Department of Planning and Zoning

TO: Development Review Board
FROM: Scott Gustin & Mary O'Neil *MO*
DATE: June 17, 2014
RE: 14-0909PD; 112-114 Archibald Street
14-0910PD 27 Bright Street
14-0911PD 35-39 Bright Street
14-0912PD 47 Bright Street

Request: Preliminary plat review of major Planned Unit Development for 44 dwelling units and associated site infrastructure and demolition of existing buildings.

PARKING LEVEL PLAN
 Scale: 1" = 20 ft

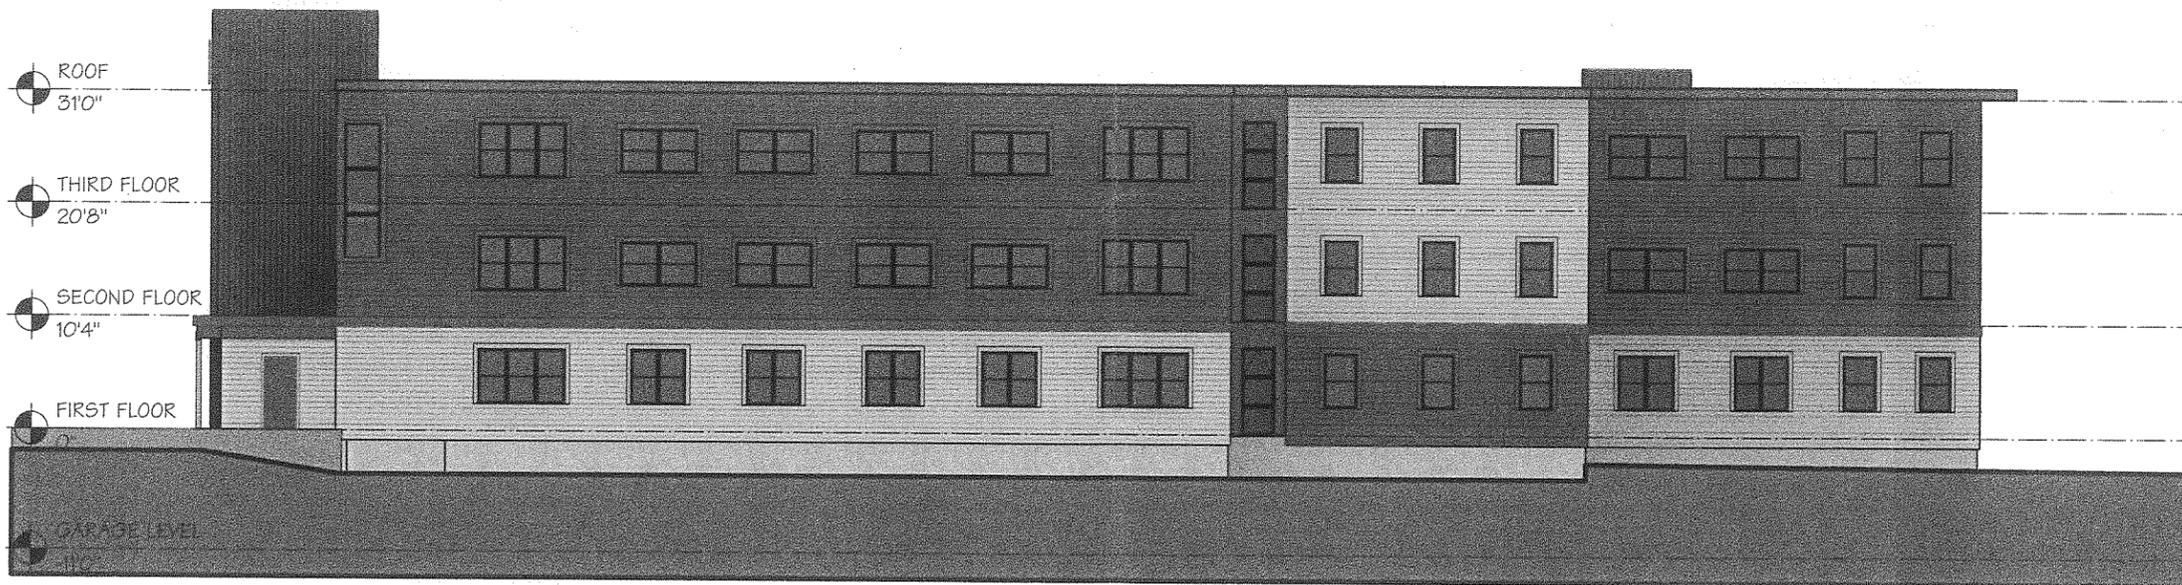
7. A plan of the parking level will be provided to allow assessment of circulation, back up distances and parking space sizes.
8. 11 long term and 4 short term bicycle parking spaces shall be provided on-site. Details and location shall be submitted prior to review by the DRB.

All new parking will be located under the central building. Two surface parking spaces are proposed behind the duplex at 112-114 Archibald Street; there are four existing parking spaces at 27 Bright Street. Detail of the interior parking garage have been submitted, confirming the adequacy of interior circulation, parking spaces and bike parking availability. **(Affirmative finding)**

5. See attached letter for written approval from the Fire Marshal.
6. See attached Parking Level Plan for the 35-Plex showing handicap parking.
7. See attached Parking Level Plan for the 35-Plex showing circulation and spaces drawn to scale.
